COUNTY OF LOS ANGELES DEPARTMENT OF PUBLIC WORKS  
LAND DEVELOPMENT DIVISION  
STORM DRAIN AND HYDROLOGY SECTION

TRACT MAP NO. 52729

TENTATIVE MAP DATED 11/04/2014  
EXHIBIT MAP DATED 11/04/2014

MAJOR LAND DIVISION  
VESTING TENTATIVE TRACT NO. 52729  
LOCATED IN THE UNINCORPORATED TERRITORY OF  
THE COUNTY OF LOS ANGELES, STATE OF CALIFORNIA

PREPARED FOR:  
**LARO Properties L.P.**

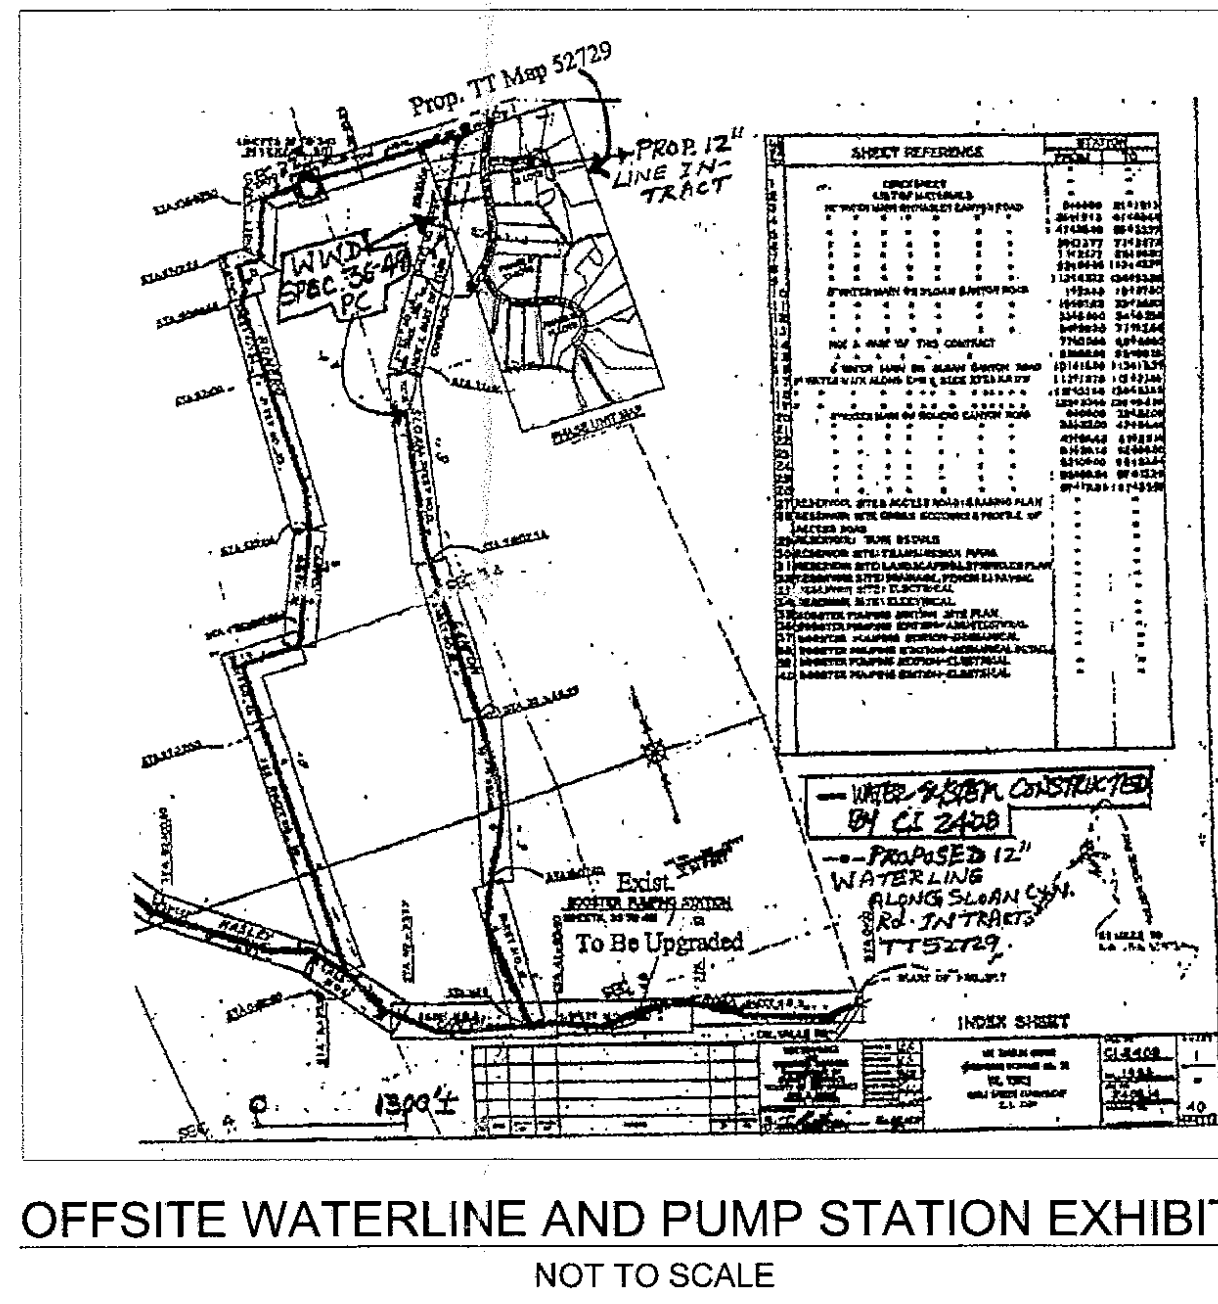
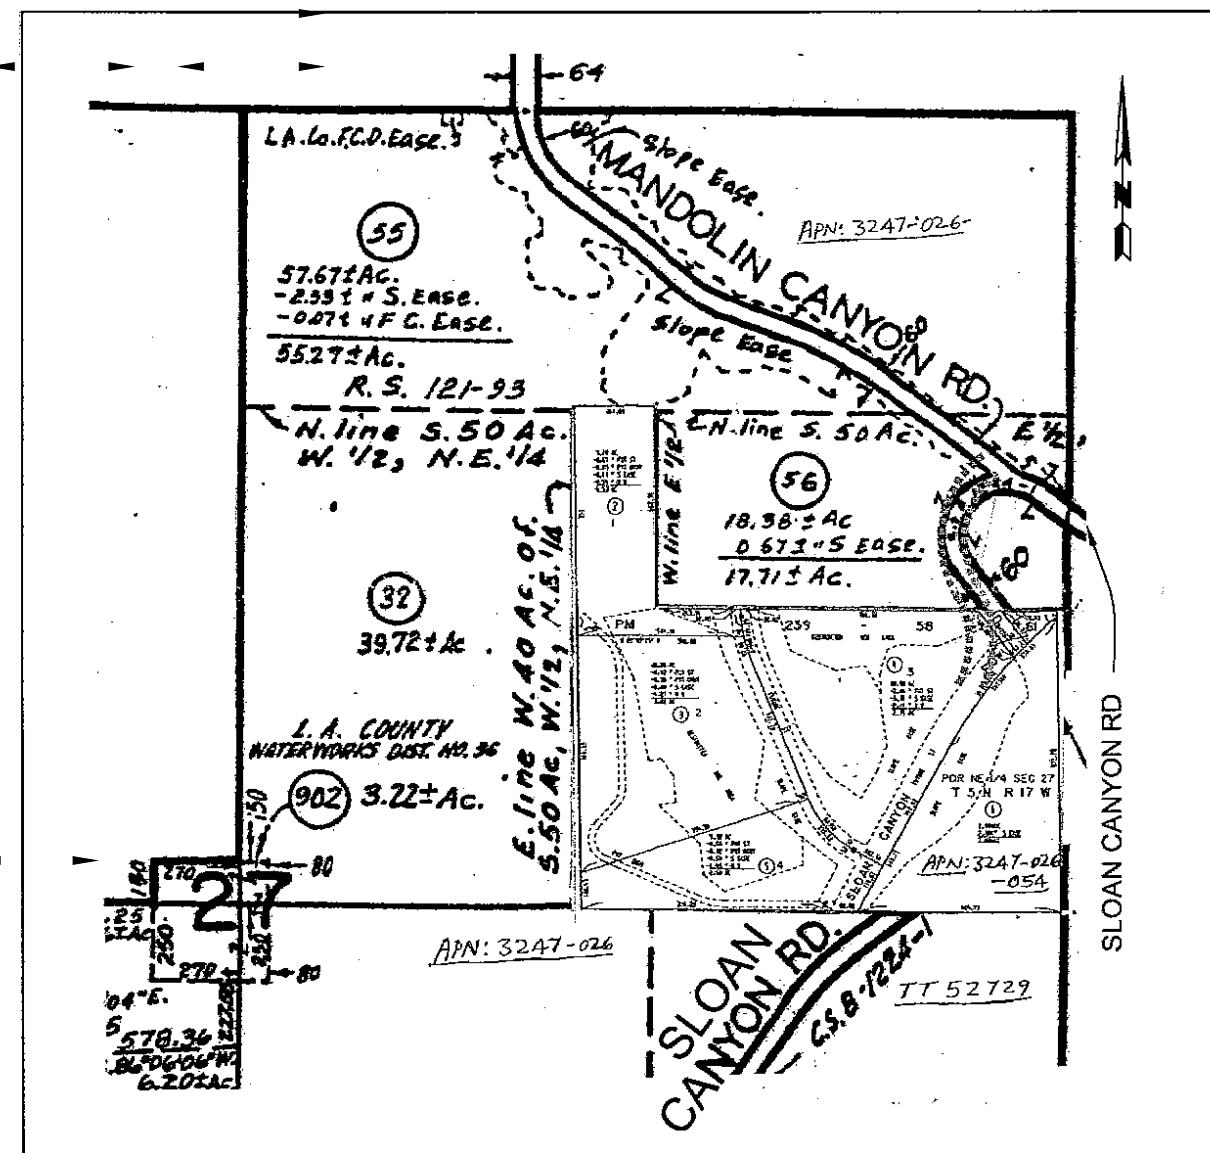
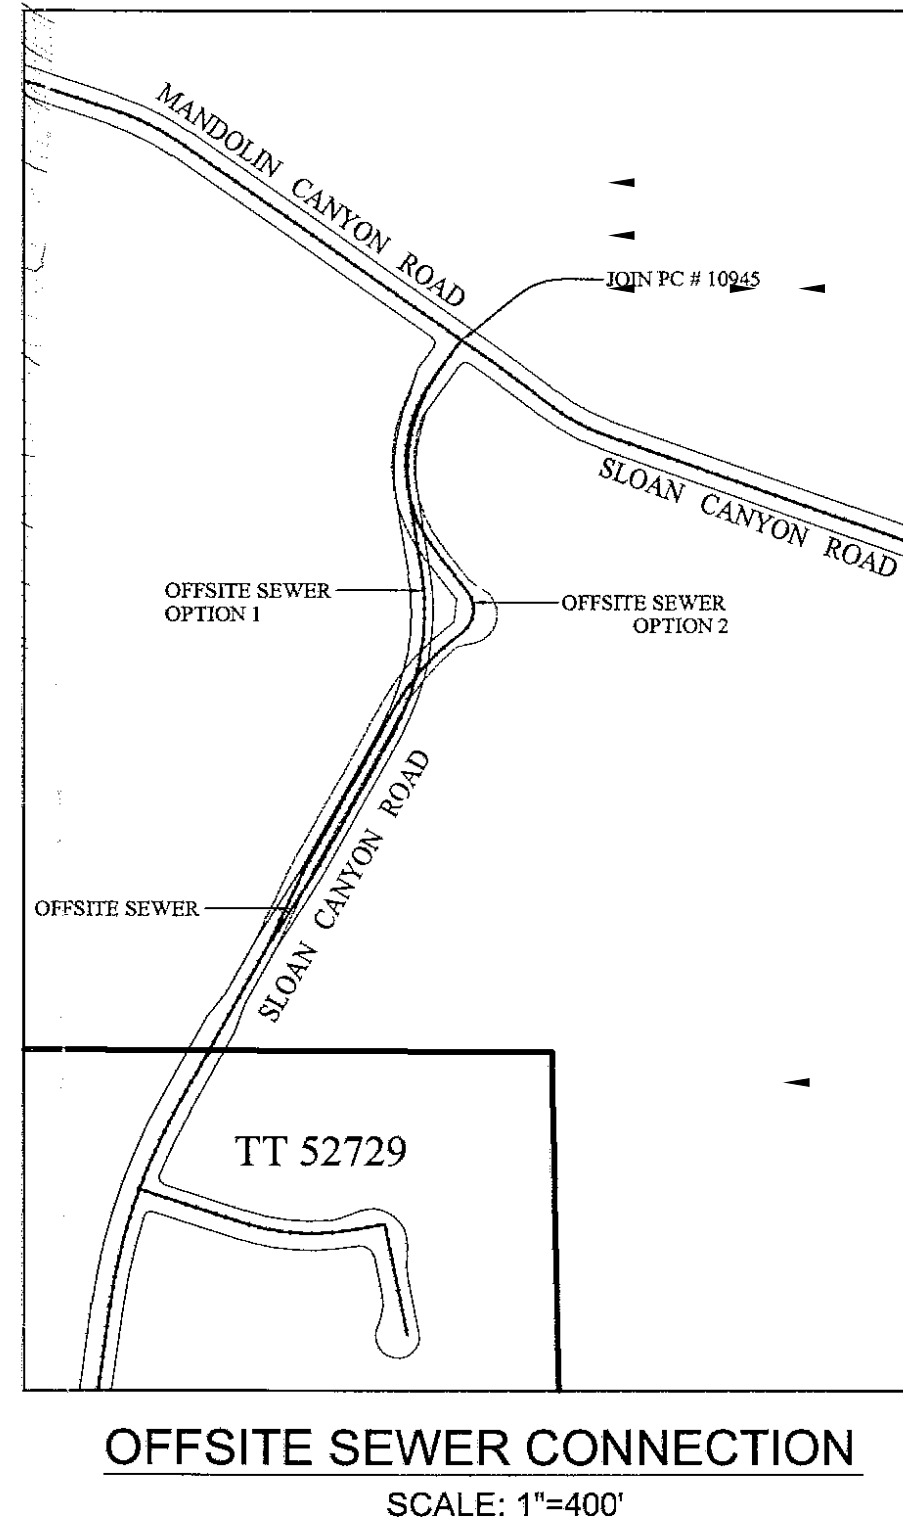
3. A revised tentative map and exhibit map. See additional road comments as shown in the attached file (2014-12-01 TTR 52729 Tentative Map checkprint.pdf) which can be found at the following ftp link:  
<ftp://dpwftp.co.la.ca.us/pub/LDD/Road/TTR%2052729r-rev4/>

show that cars will not  
scrape as they exit the  
driveway without  
proper landing, typ.  
Adjust grading  
accordingly

not applicable with inverted shoulders and not consistent with HDO, Healthy Design Ordinance

proposed grades are higher than the maximum grades required for local streets per Title 21, —Section 21.24.100; therefore request permission to allow up to \_\_\_\_% as part of a note on the tentative map

not applicable with inverted shoulders and not consistent with HDO, Healthy Design Ordinance

proposed grades are higher than the maximum grades required for local streets per Title 21, —Section 21.24.100; therefore request permission to allow up to \_\_\_\_% as part of a note on the tentative map
